Subject: Class 1 Permit Modification Notifications, Waste Isolation Pilot Plant Hazardous Waste Facility Permit Number: NM4890139088-TSDF

**Class 1 Permit Modification Notifications**

**Waste Isolation Pilot Plant  
Carlsbad, New Mexico**

**WIPP Permit Number - NM4890139088-TSDF**

**Figure B2-3**  
**Planimetric - Map-WIPP Facility Boundaries**

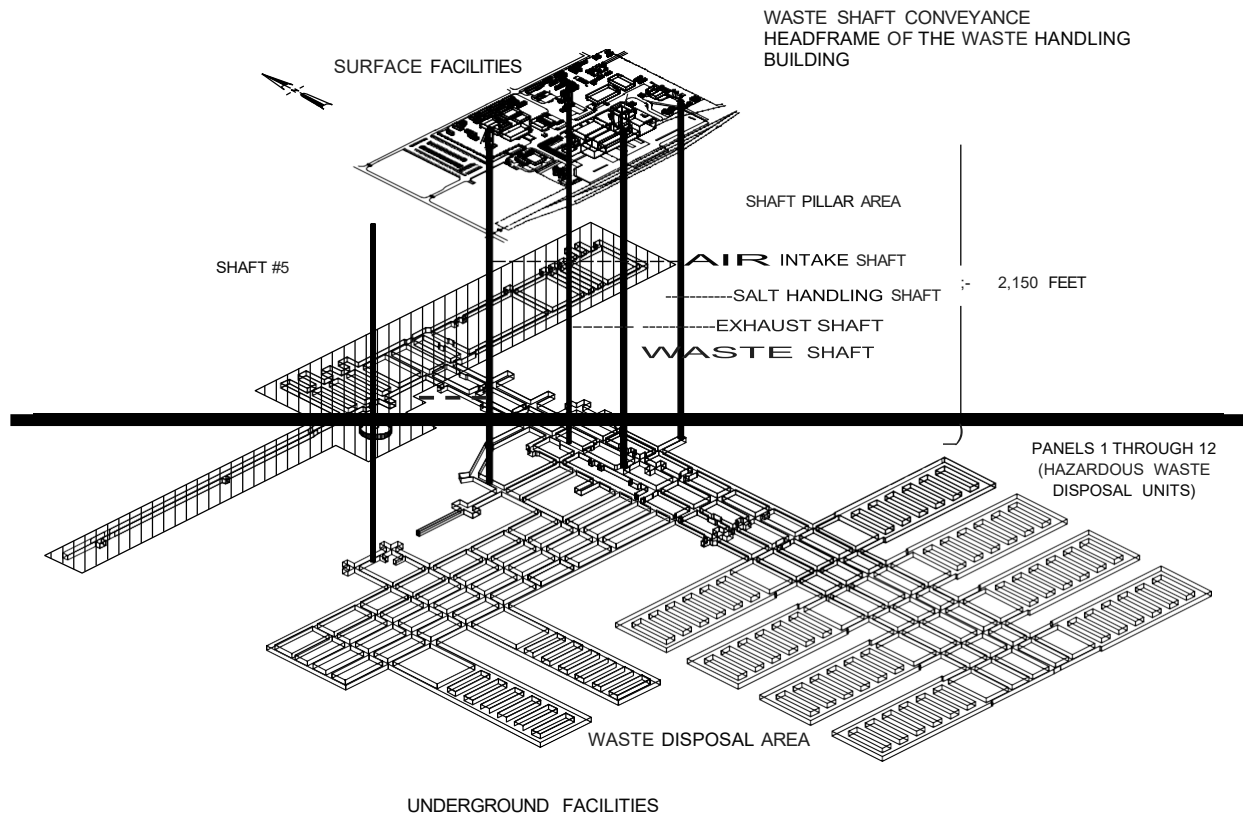
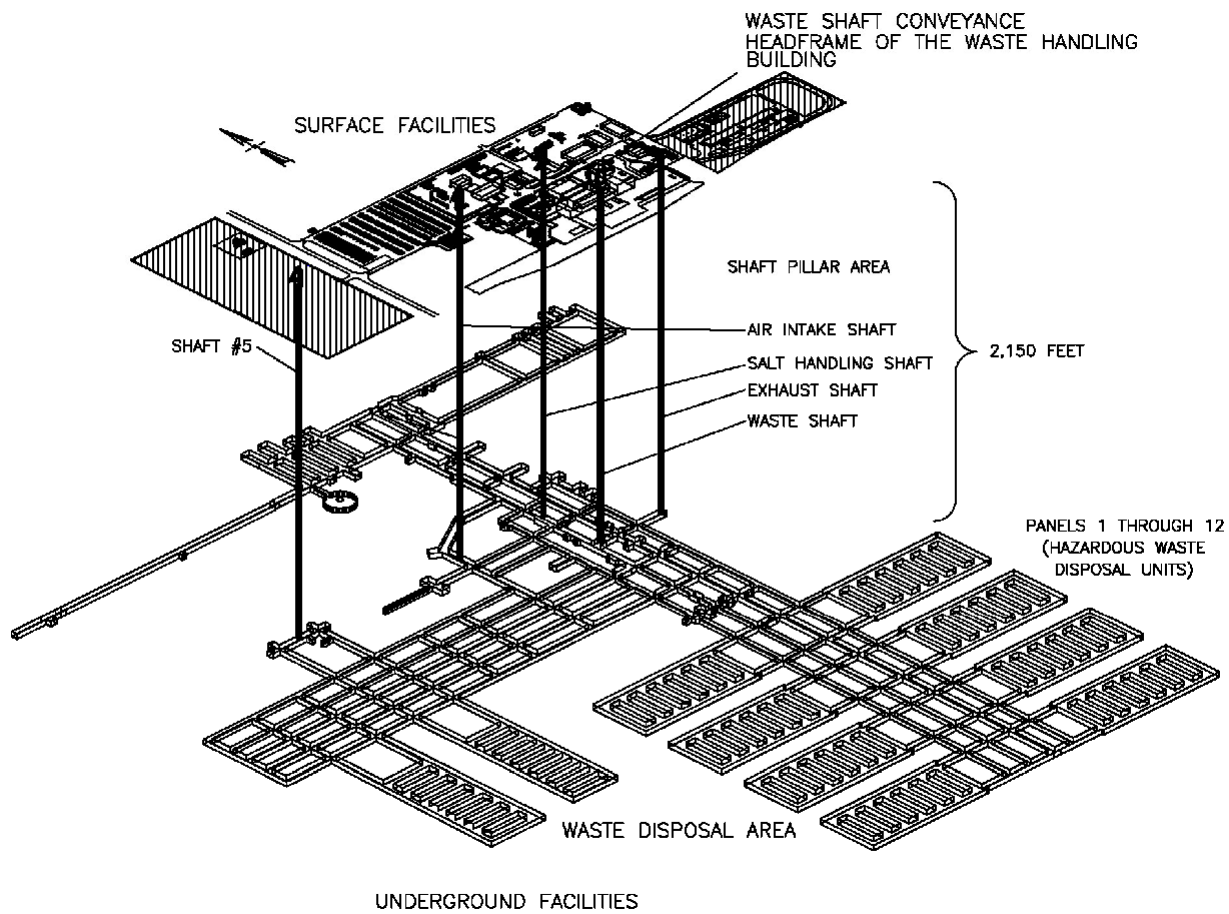
- Figure B2-3, *Planimetric - Map-WIPP Facility Boundaries*
    - Replaced this figure with a new figure which depicts the updated PPA fence line and nearby public accessible roads.

Permit Attachment B, Figure B2-3, and Permit Attachment M, Figure M-66, have been replaced with a figure that more appropriately depicts the facility boundaries. The railway and private roads have been removed from these figures. The Permittees have no plans to use the railway and removing the private roads ensures that only roads that could be accessed by the public are depicted. These changes are needed to ensure the information in the figures are current and consistent.

**Figure B3-1**  
**Spatial View of the WIPP Facility**

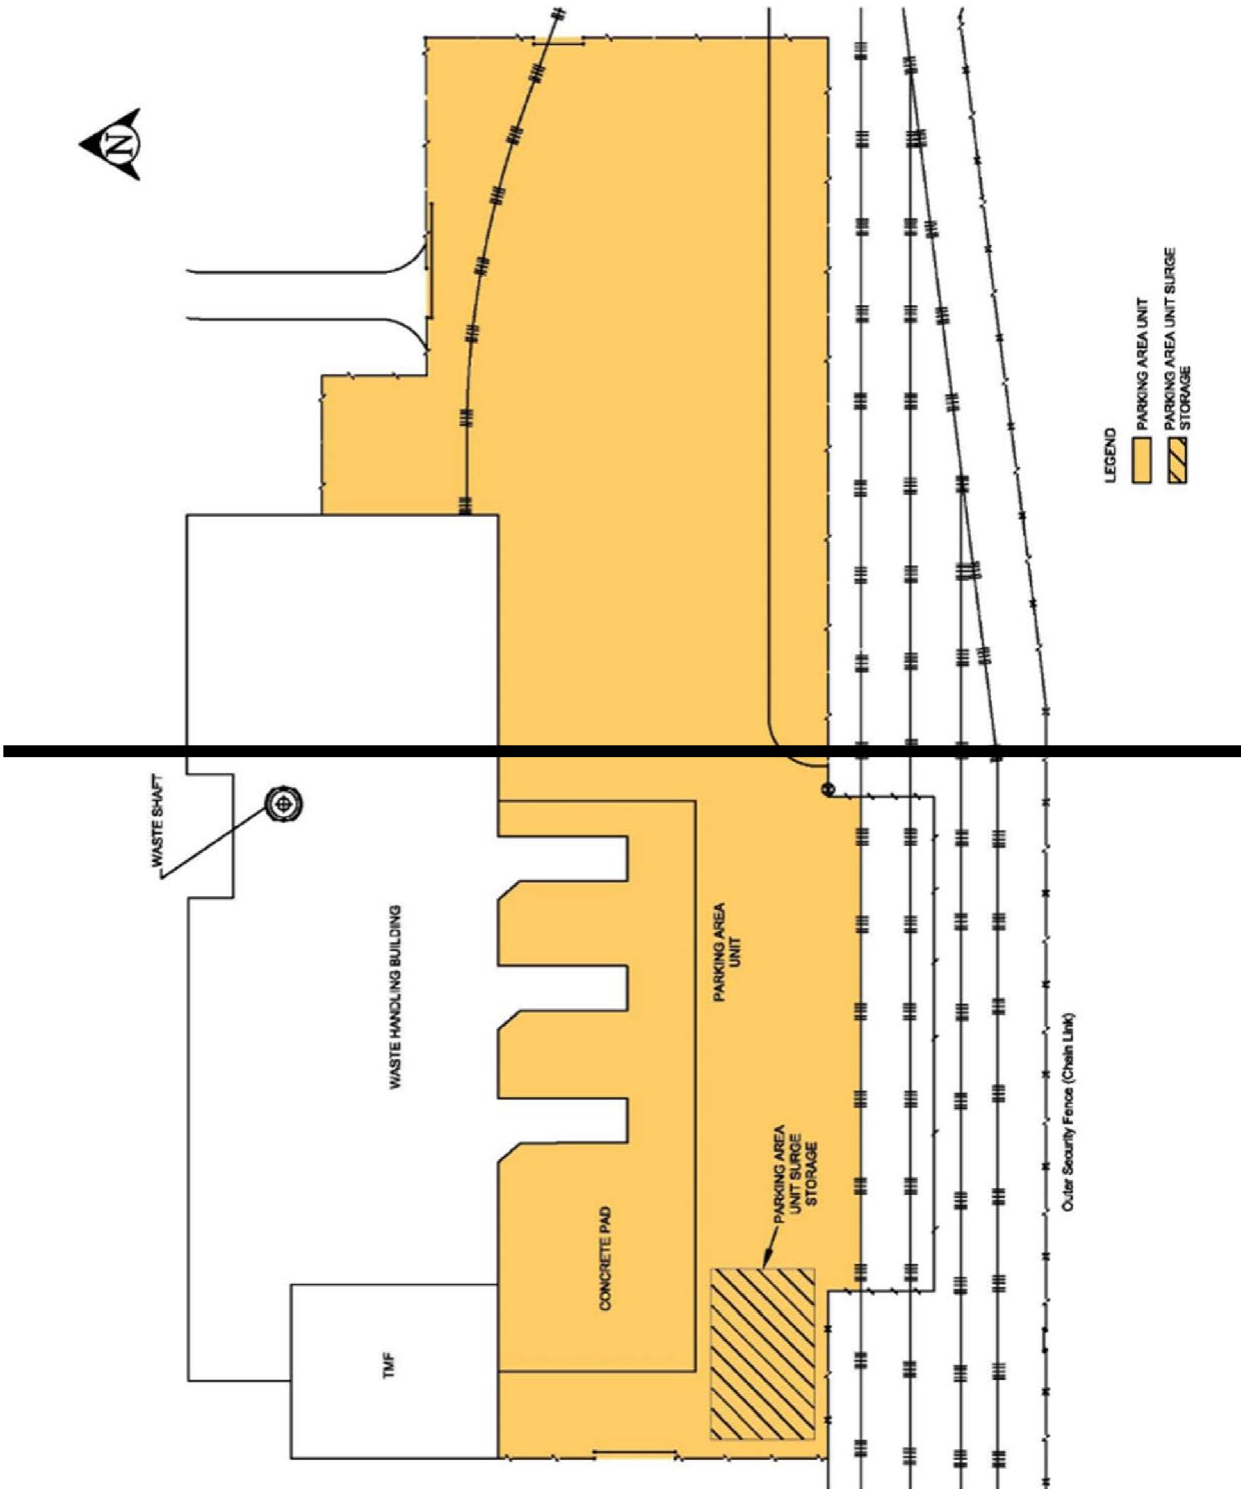
- Figure B3-1, *Spatial View of the WIPP Facility*
    - Updated the figure with the Shaft #5 and the Safety Significant Confinement Ventilation System (**SSCVS**). Updates were also made to the buildings and structures to ensure consistency with other figures in the Permit that show the surface structures and to ensure consistency with the current layout of the facility.

Permit Attachment B, Figure B3-1, Permit Attachment D, Figure D-2, and Permit Attachment M, Figure M-44, have been replaced with a figure that includes the Shaft #5 and SSCVS areas and updated other areas to ensure consistency with other figures that depict the surface and underground facilities and ensure consistency with the current layout of the facility.

**Figure B3-3**  
**Parking Area Unit - TRU Mixed Waste Container Storage and Surge Areas**

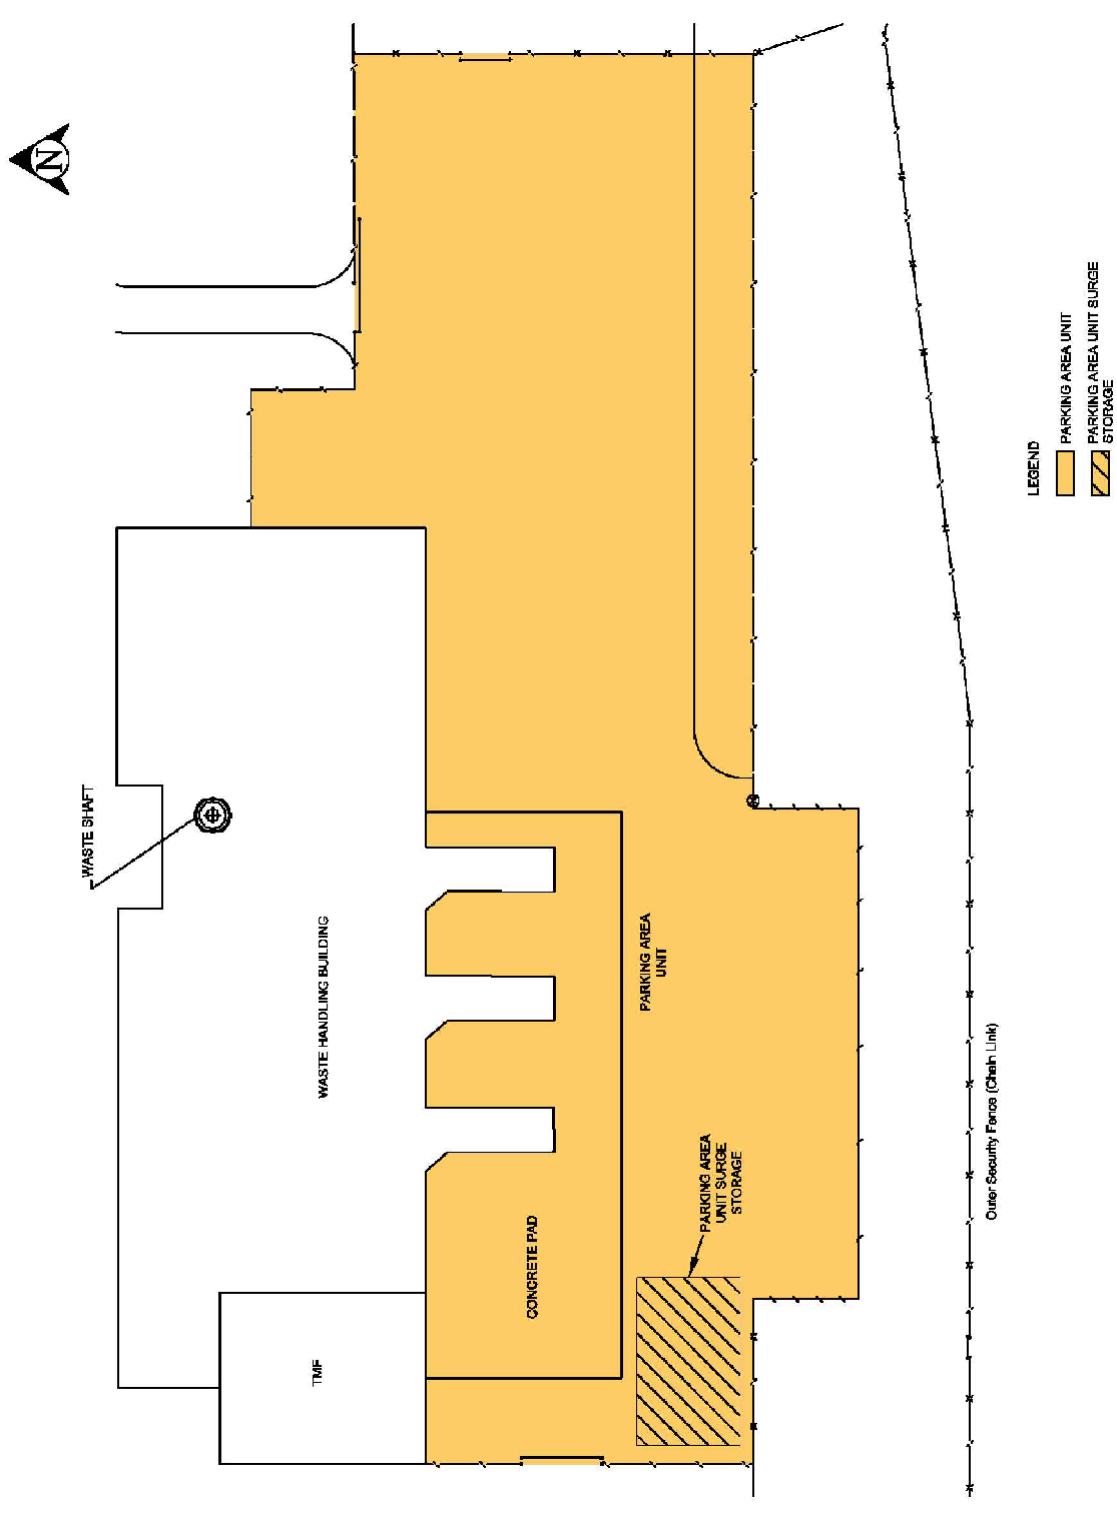
- Figure B3-3, *Parking Area Unit - TRU Mixed Waste Container Storage and Surge Areas*
    - Updated figure to remove the rail sidings (tracks), updated southeast fence line, and extended shading on the figure to the fence line.

Permit Part 3, Section 3.1.2, has been updated to remove the reference to rail tracks. Figures B3-3 and M-2 have been updated to remove the rail tracks and extend the shading to the southern fence line. These changes are needed since the rail tracks are not being used and have been removed. These changes ensure the text and figures are consistent with the text in Permit Attachment A, Section A-4, and Permit Attachment A1, Section A1-4, which describe the
